September 11, 2024

Project No: 100200.32

**ADDENDUM NO. 2
TO THE CONTRACT DOCUMENTS AND DRAWINGS**

**For the construction of the
Aloe Bay Water Quality Enhancement Wastewater Treatment Facility**

CHLORINE CONTACT BASIN SECTIONS

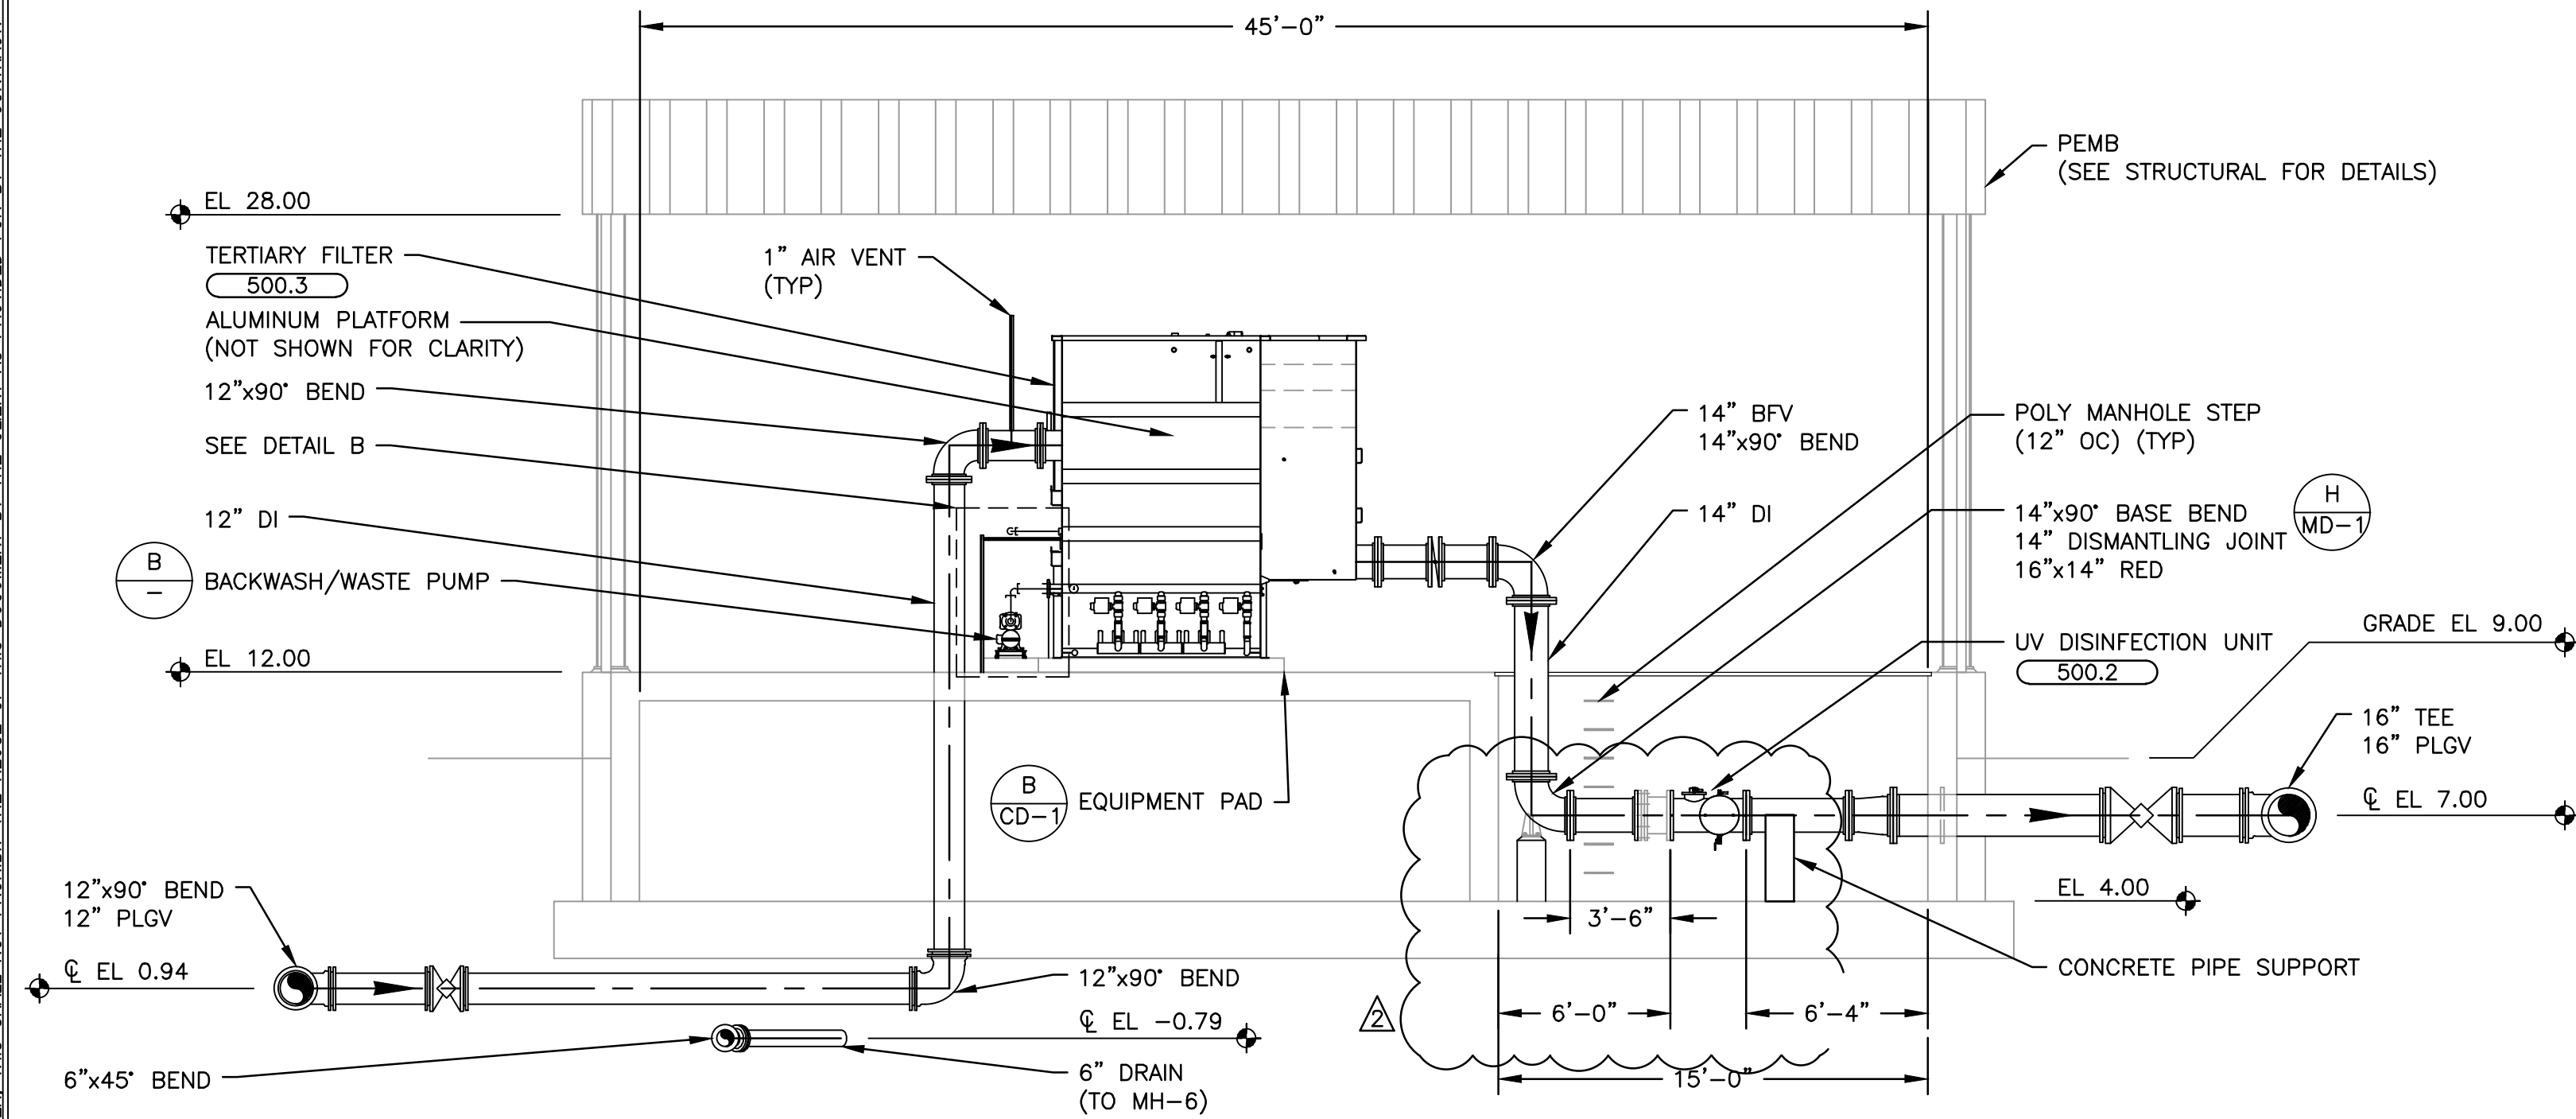
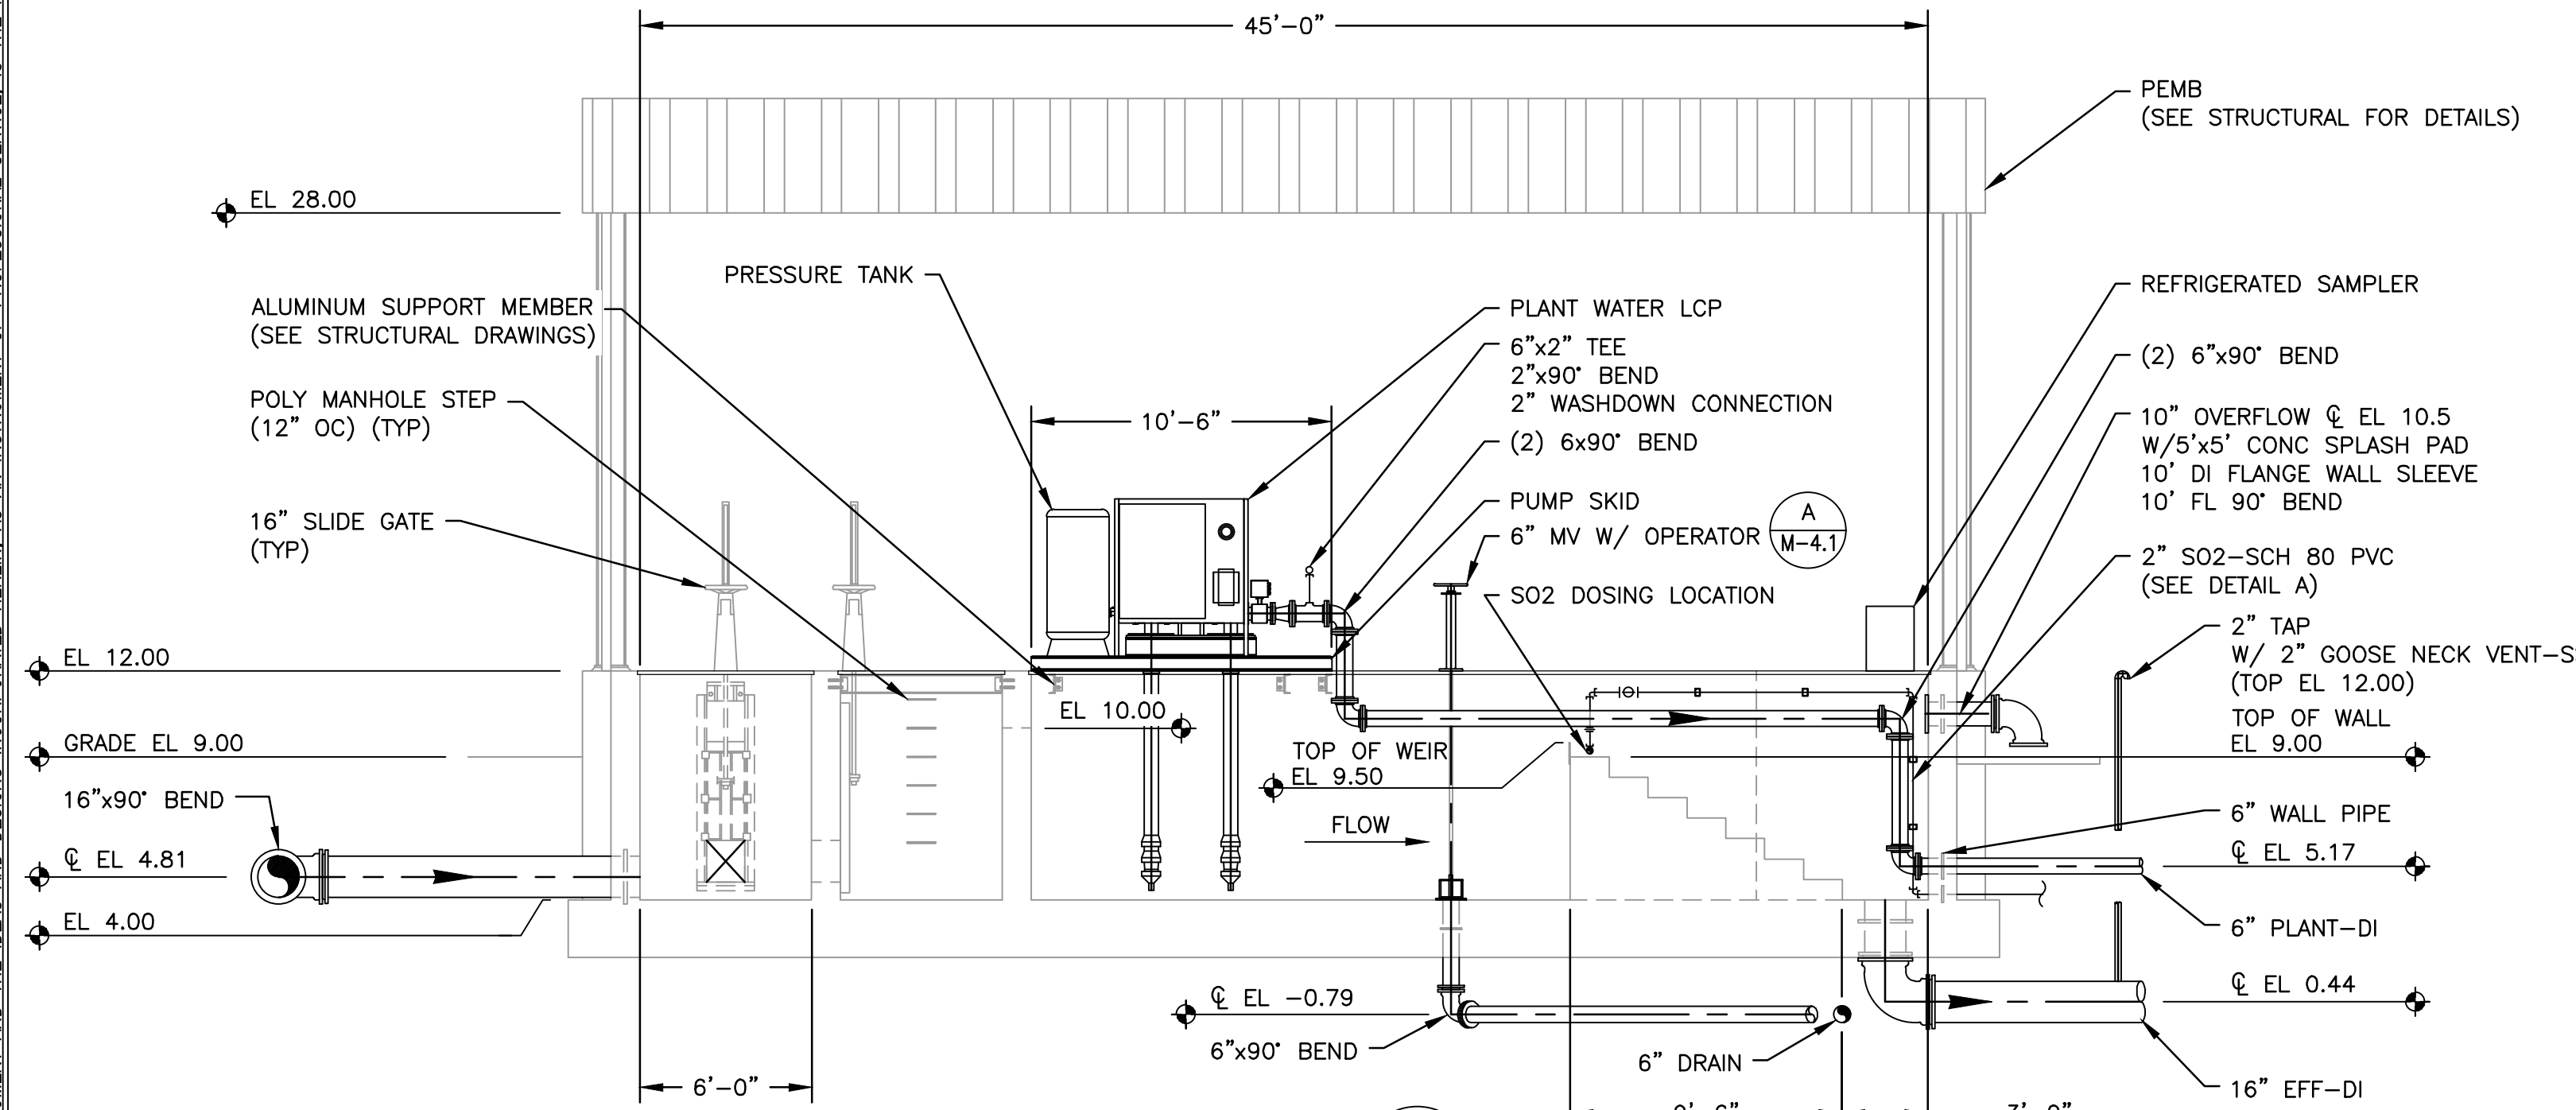
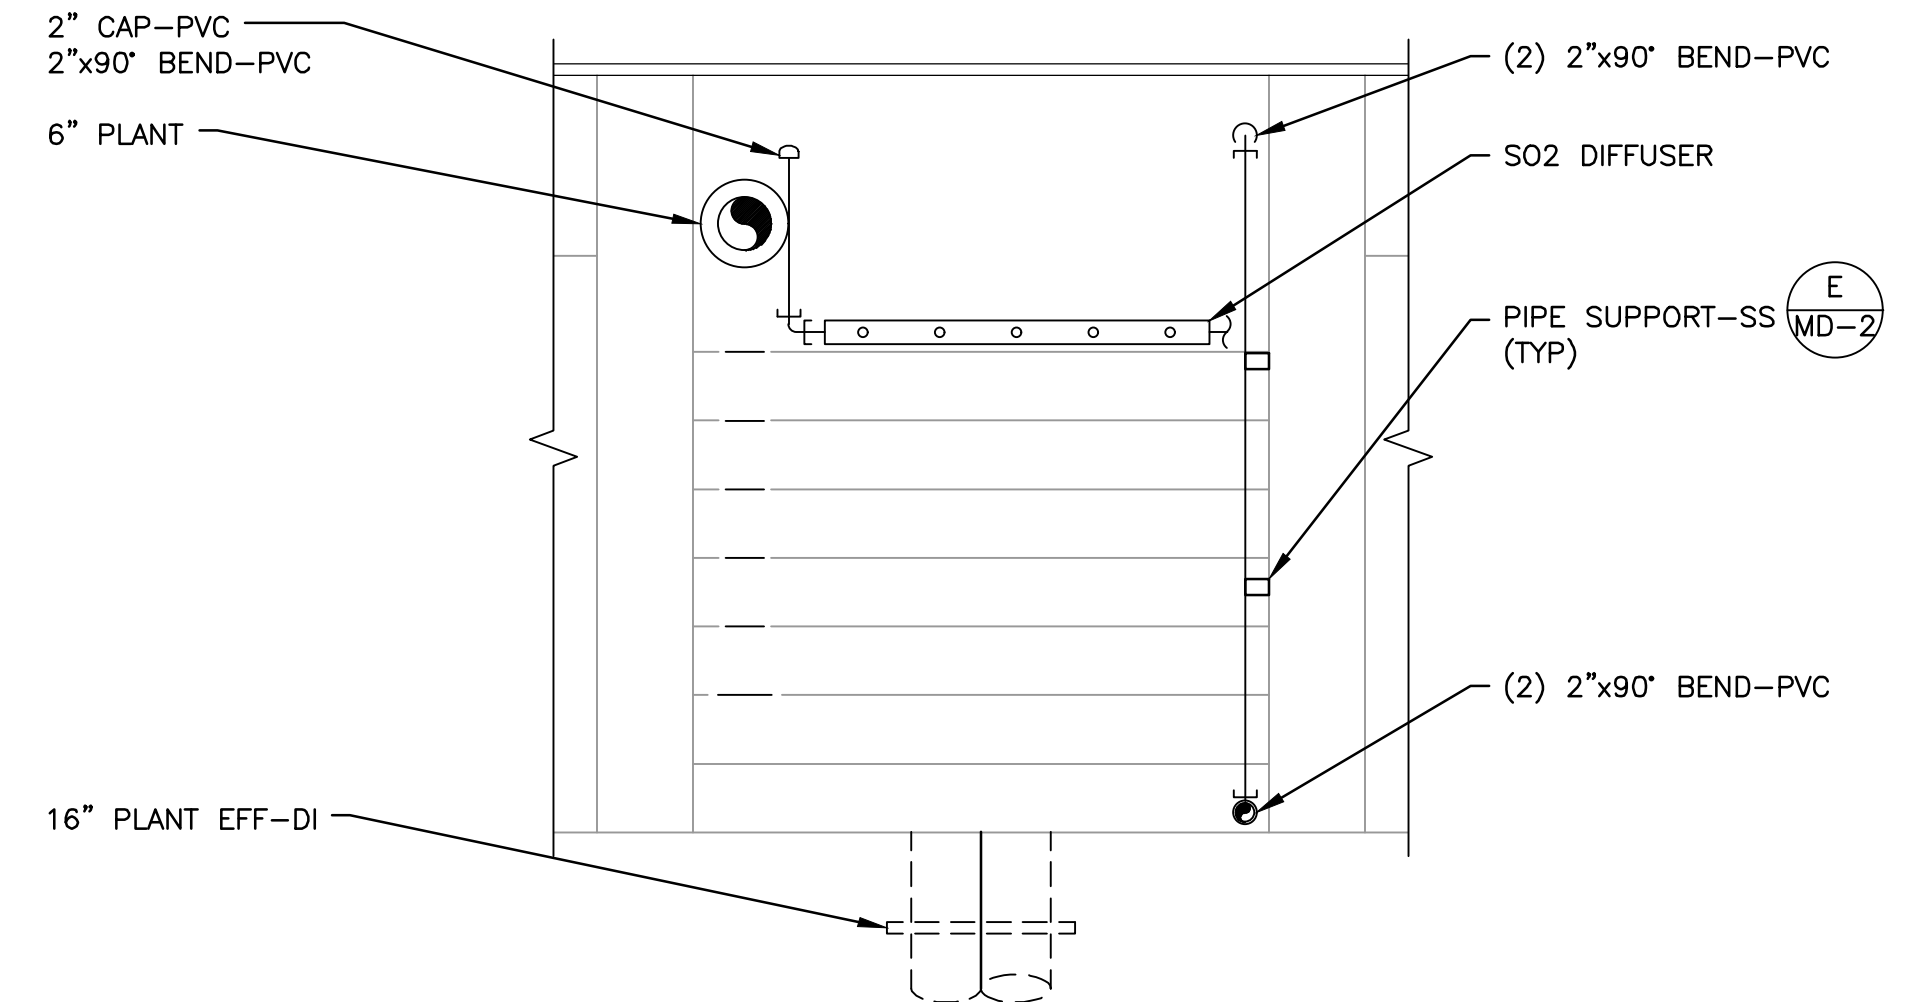
2	9/6	ADDENDUM 2	BL	JS
DESIGNED BY:	DATE	REVISION	APPROVED BY:	APPROVED BY:
BL		DRAWN BY:	JS	
		LR	SC
